ADDENDUM NO. 1A

Good Shepherd Catholic Church Community Center

July 27, 2026

GRC Project 21275

SHEET
P2.32

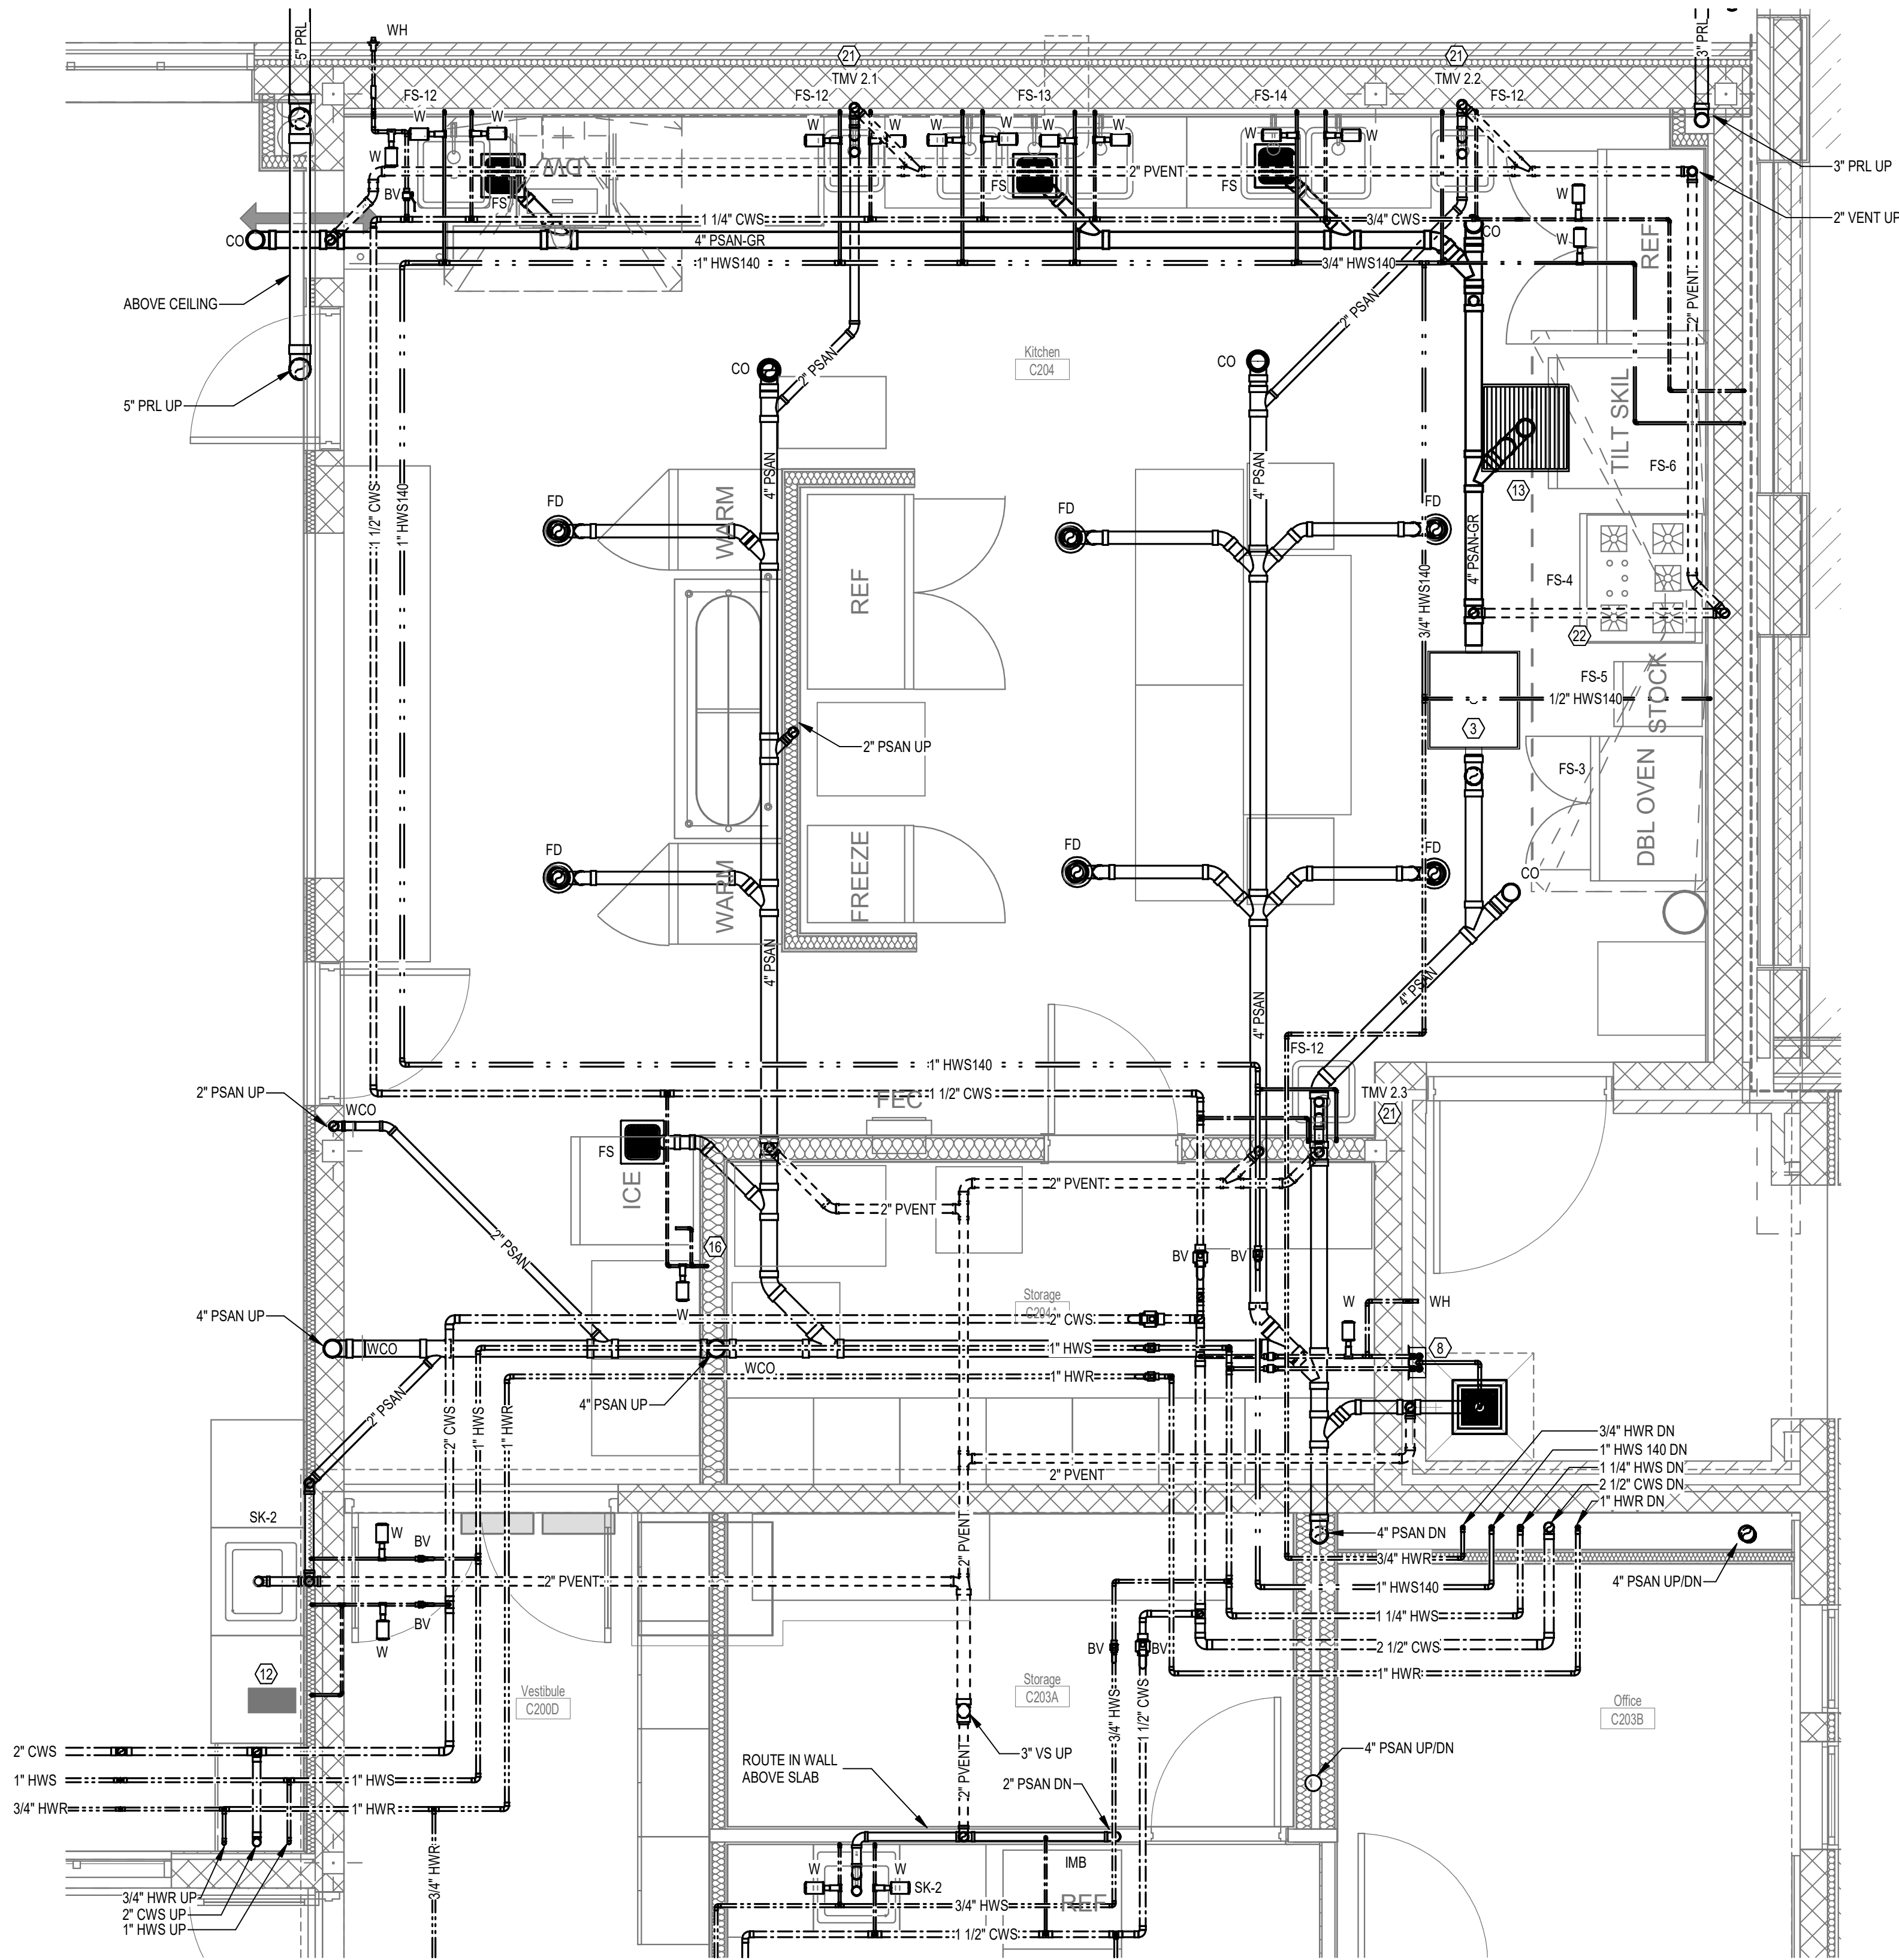
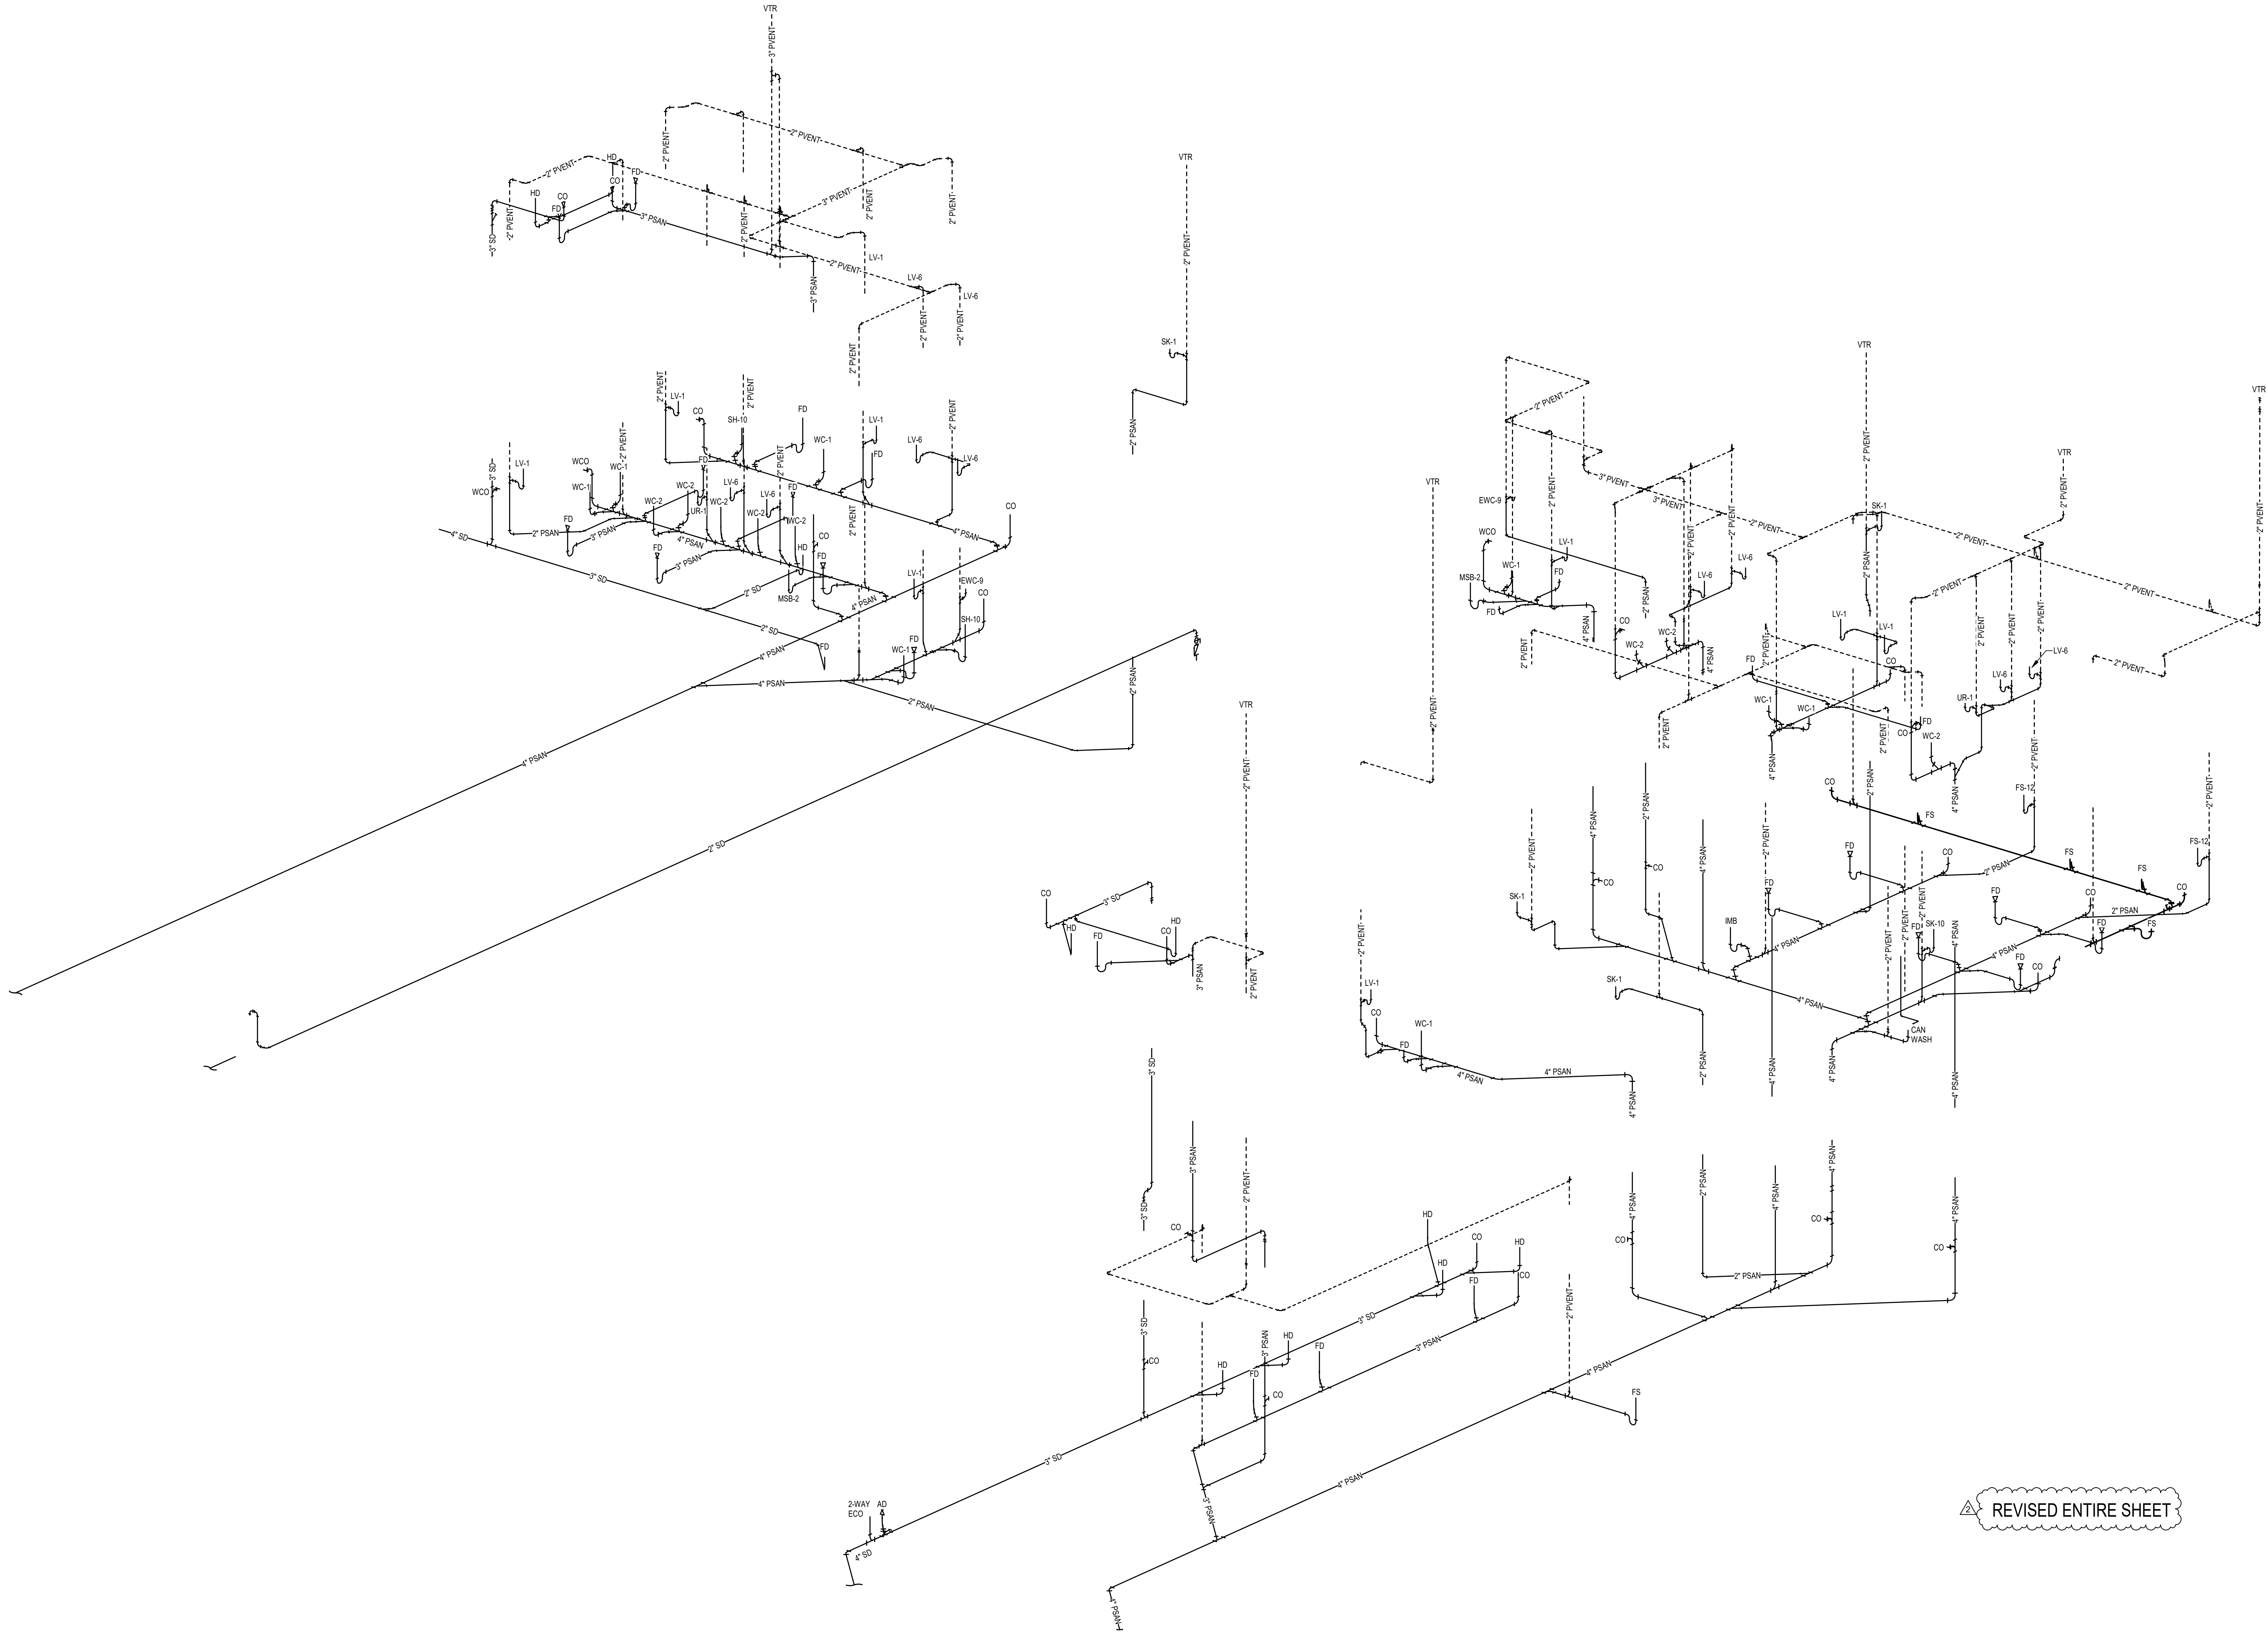
- Item P1.1.7 **Revise** overall plumbing engineering design of the following systems:
Sanitary, venting, domestic cold-water supply, domestic hot water supply and return and domestic hot-water 140 supply and return.
Revise Plumbing Plan Keynote 3.
Remove everything related to the scope of natural gas. Natural gas lines now has its own set of plans.

SHEET
P3.01

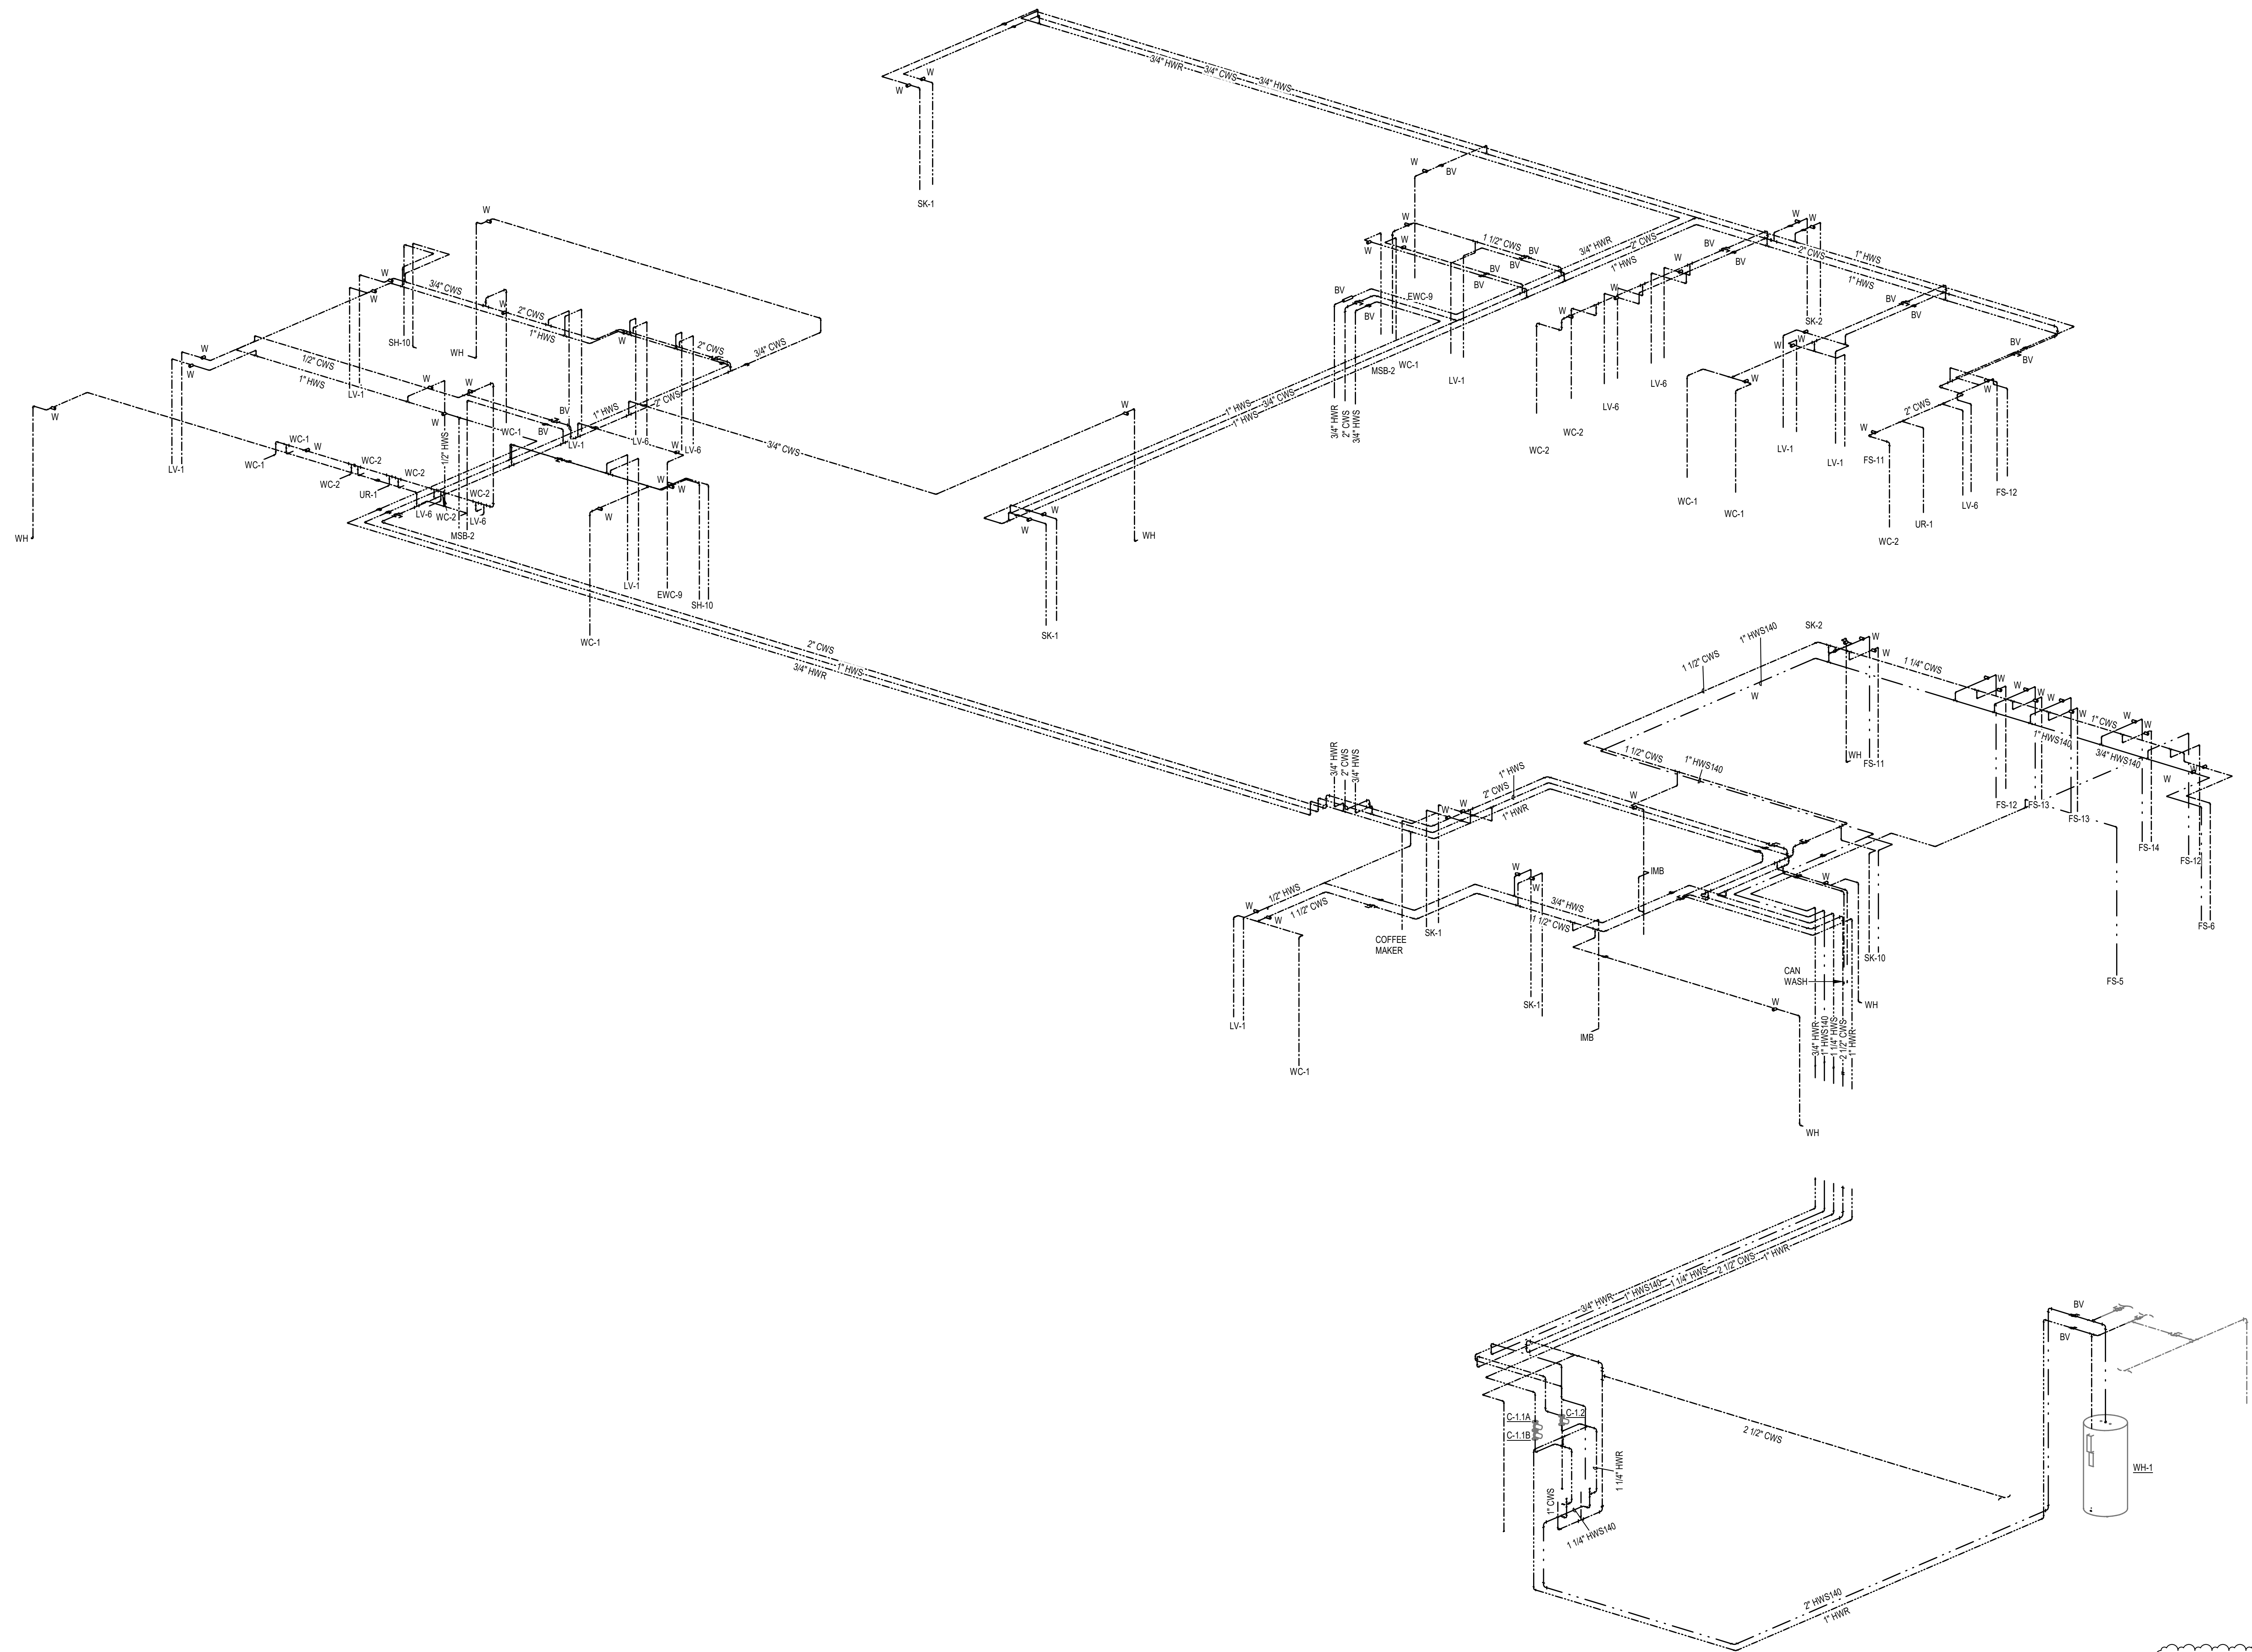
- Item P1.1.8 **Revise** overall sanitary design. Layout reflects changes discussed in previous items.
